Document title: DOE/Sandia Responses to the NMED's Comments in "Notice of Disapproval: Environmental Restoration Project Consolidated Quarterly Report, September 2010"

**U.S. Department of Energy/Sandia Corporation Responses
to the New Mexico Environment Department's Comments
in
"Notice of Disapproval, Environmental Restoration Project
Consolidated Quarterly Report, September 2010
Sandia National Laboratories,
EPA ID# NM5890110518, HWB-SNL-10-016"**

Revisions to September 2010 ER Project Consolidated Quarterly Report in Response to the NOD Comments from the NMED

Figure A-3
Potentiometric Surface Map for the
Chemical Waste Landfill, March 2010

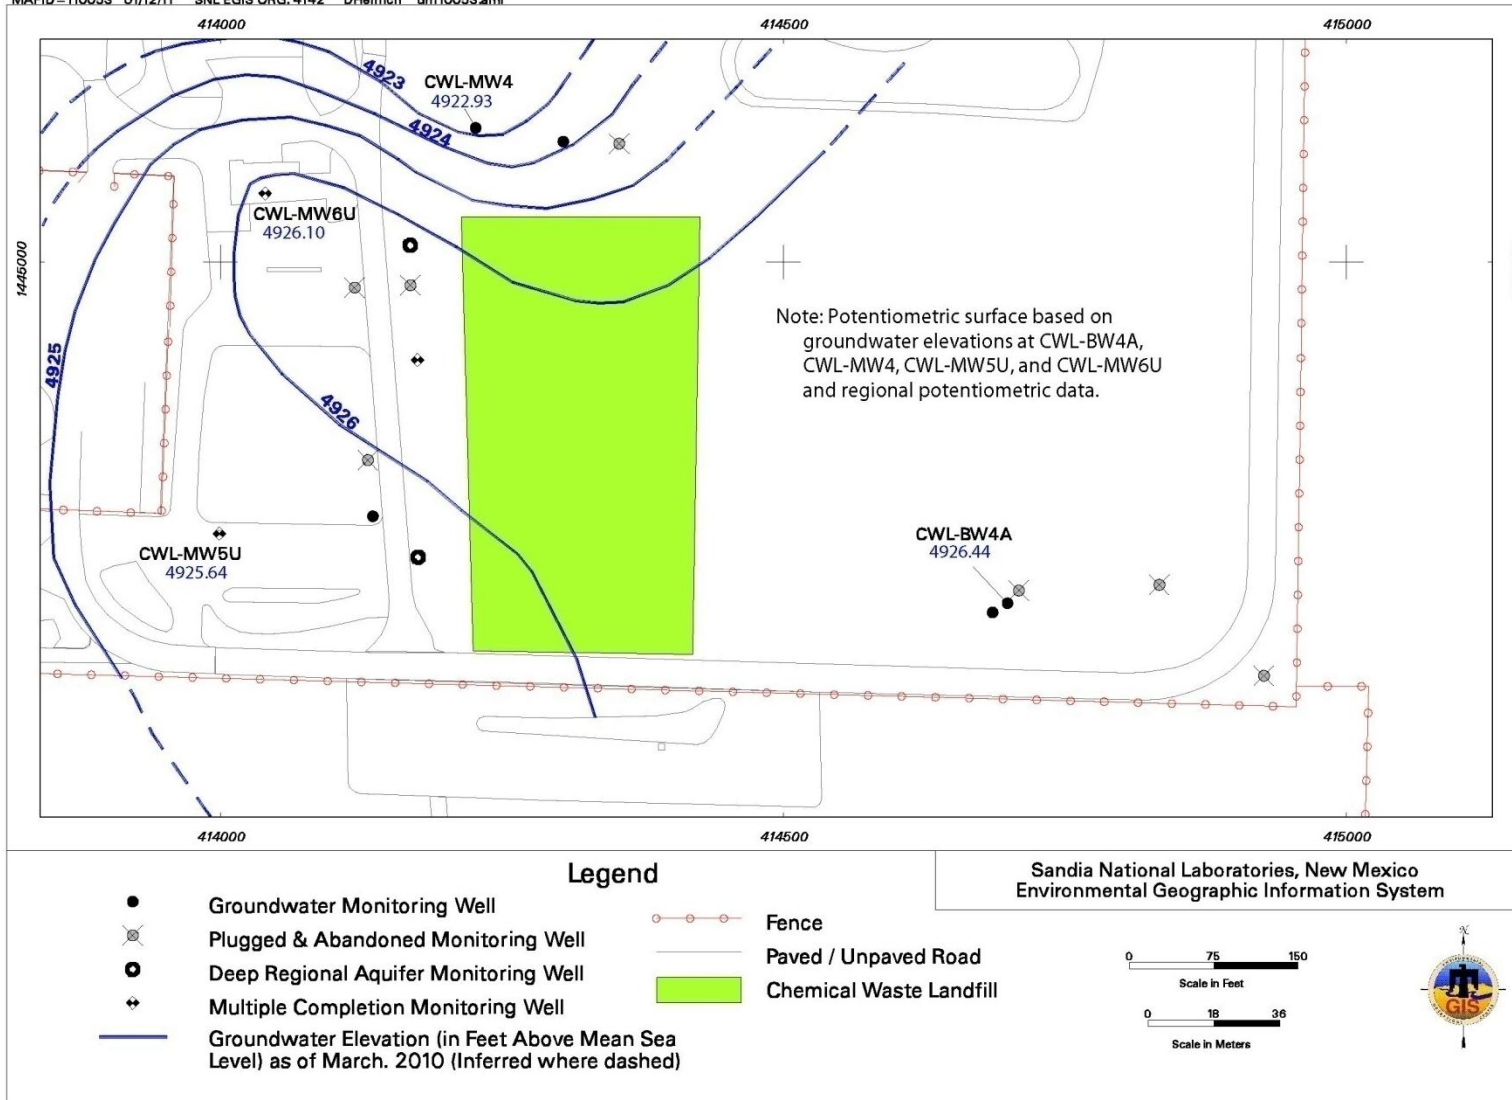
4. **The Permittees must submit a potentiometric surface map for the Chemical Waste Landfill based on groundwater levels measured during the particular reporting period in the CQ Report and future reports.**

Response: The requested potentiometric surface map, showing groundwater elevation as of March 2010, addresses this change and is provided in Attachment C as Figure A-3. Updated potentiometric surface maps will be provided with future CQ Reports in Appendix A of Section II.
